RHODE ISLAND DEPARTMENT OF TRANSPORTATION

RHODE ISLAND CONTRACT NO.2014-CH-028

Apponaug Circulator By-Pass

ADDENDUM NO. 2 Prospective bidders and all concerned are hereby notified of the following changes in the Plans, Specifications, Proposal and Distribution of Quantities for this contract. These changes shall be incorporated in the Plans, Specifications, Proposal and Distribution of Quantities, and shall become an integral part of the Contract Documents.

CROSS SECTION
STATION 33+00

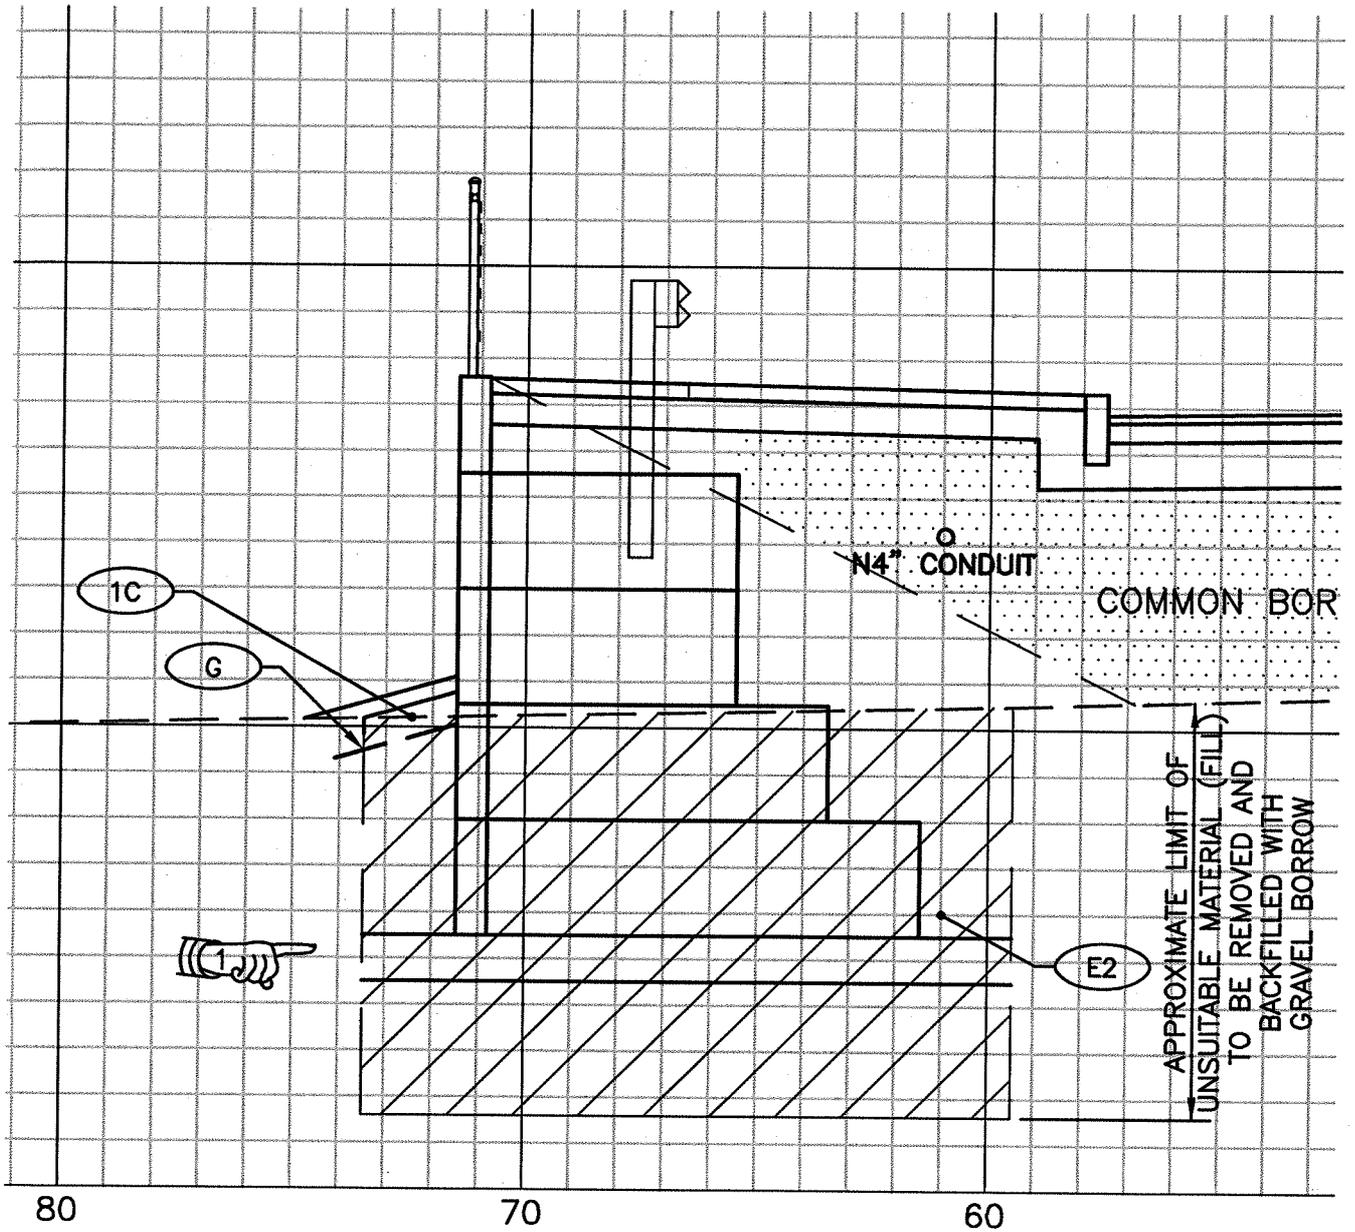
9. Volume 2 of 4 – Sheet No. 41 – Cross Section Station 33+00
Revise Sheet No. 41 as shown on Sketch No. 9(R-1) attached to this Addendum No. 2. The elevation and width of the Modular Wall Footing has been revised, and limits of unsuitable material below wall, to be removed, has been clarified.

CROSS SECTION
STATION 33+50

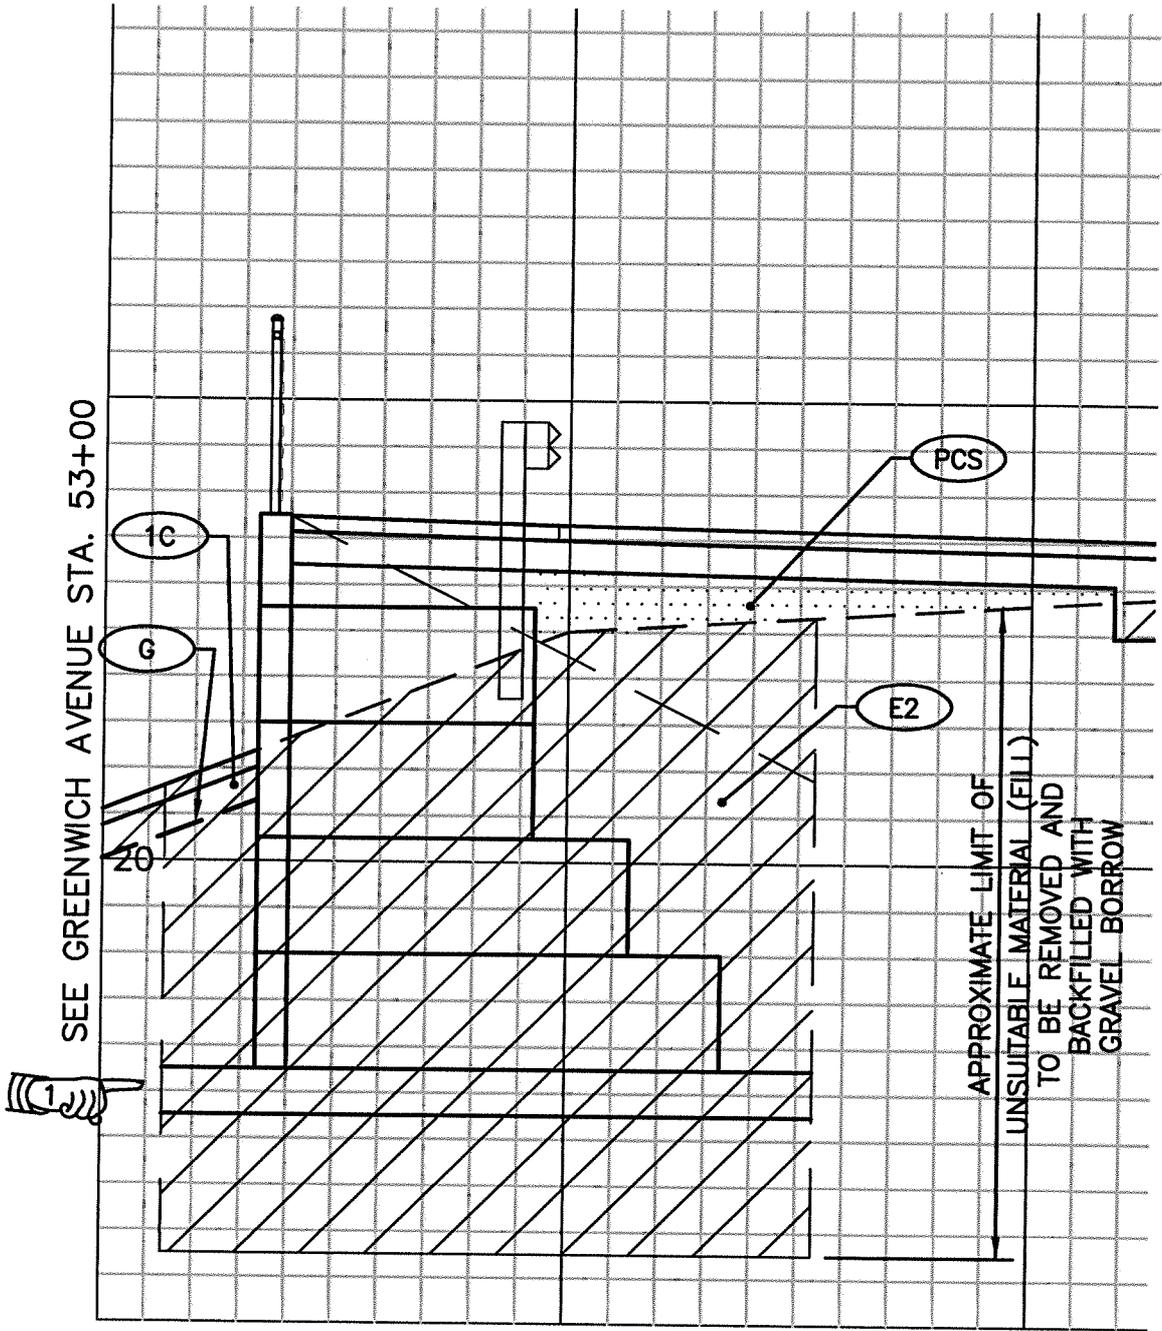
10. Volume 2 of 4 – Sheet No. 42 – Cross Section Station 33+50
Revise Sheet No. 42 as shown on Sketch No. 10(R-1) attached to this Addendum No. 2. The elevation of the Modular Wall Footing has been revised, and limits of unsuitable material below wall, to be removed, has been clarified.

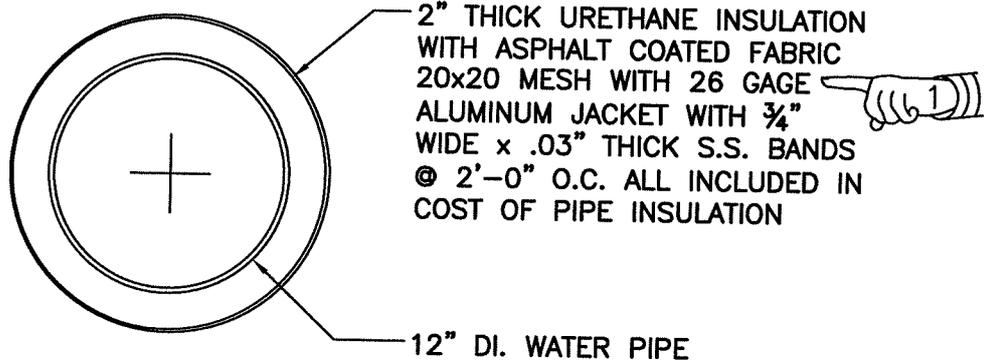
12. Volume 3 of 4 – Sheet No. 7 – Precast Bridge Details
Revise Sheet No. 7 as shown on Sketch No. 12(R-2) attached to this Addendum No. 2. The Fascia Unit Connectors have been added to the Bridge Plan.
